TO: Mercedes-Benz Dealer Principals, General Managers, Sales Managers, Service Managers, Parts Managers	FROM: Gregory Gunther, Department Manager, Vehicle Compliance and Analysis, Engineering Services
RE: Recall Campaign Launch Notification Rework Wiring Harness for Communication Module MY20 190 (AMG GT-Class)	DATE: June 26, 2020

Campaign No. 2020060010, June 2020

SUBJECT: **Model AMG GT-Class (190 platform)**
Model Year 2020
Rework Wiring Harness for Communication Module

Figure 1

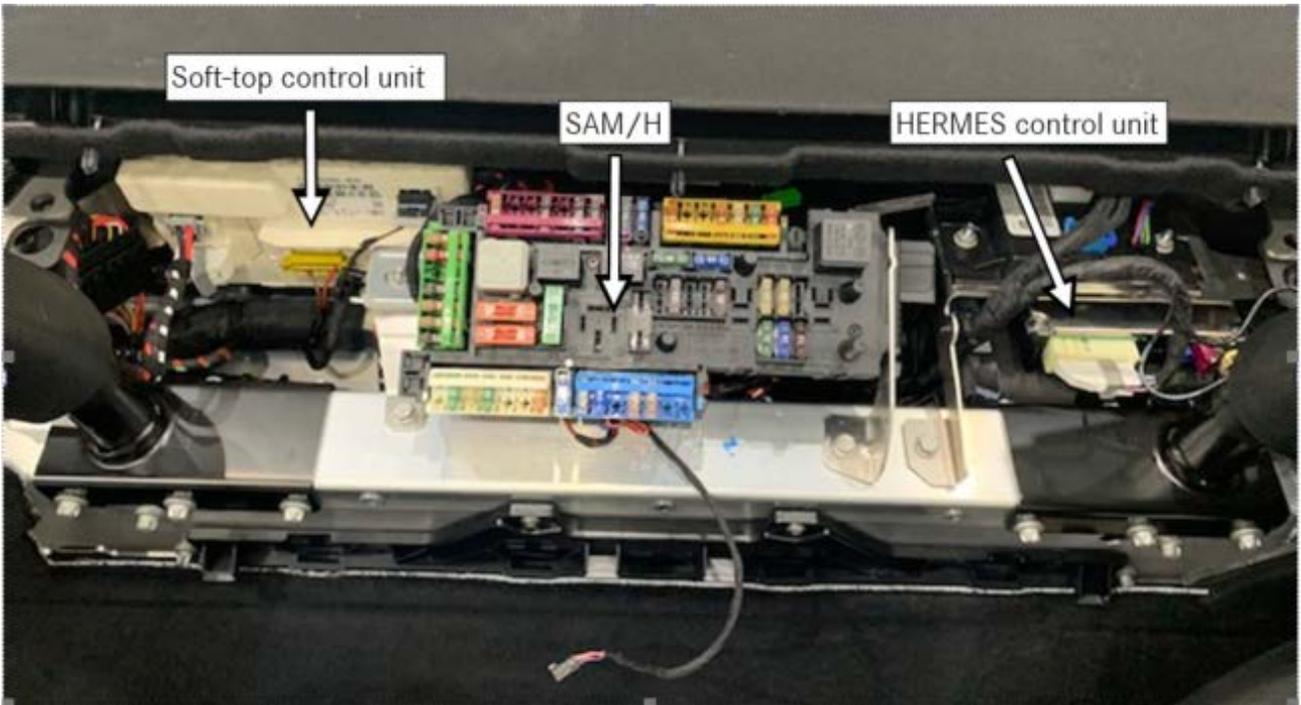
1. Clamp off ground line.
2. Expose HERMES control unit.
 - i For basic data, see **AR82.95-P-0019RGR**.
 - i All operation steps for exposing are described in the WIS document.
 - i HERMES control unit **does not have to** be removed.
 - i The aftermarket ground line is routed from the soft top control unit to the HERMES control unit.

Figure 3

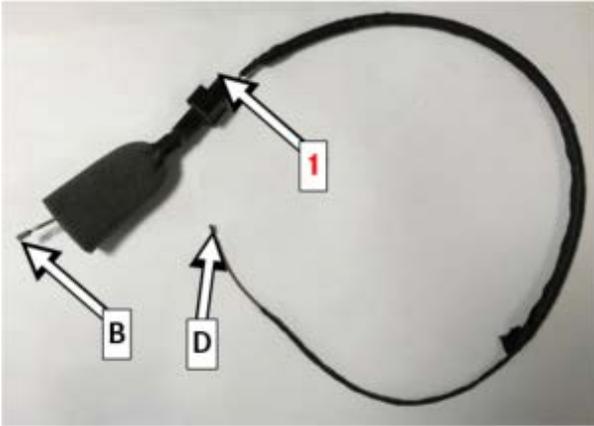
4. Disconnect existing cable (brown) from PIN C connection from chamber 8 (**figure 4**) and connect in free chamber of the socket housing of wiring harness A190 540 26 09 (**1, figure 3**).
5. Insert loose pin (**B, figure 3**) of the aftermarket ground wiring harness into **chamber 8 (C, figure 4)** of the lower row and reconnect plug to soft top control unit.

Figure 6

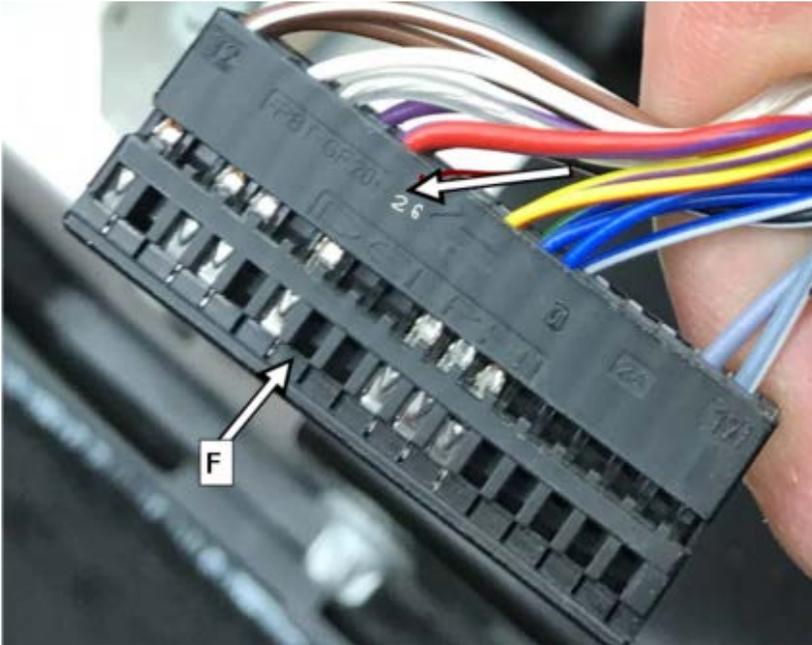
7. Insert loose pin (**D, figure 3**) of the ground wiring harness into **chamber 26 (F, figure 6)**, complete plug and connect to HERMES control unit.
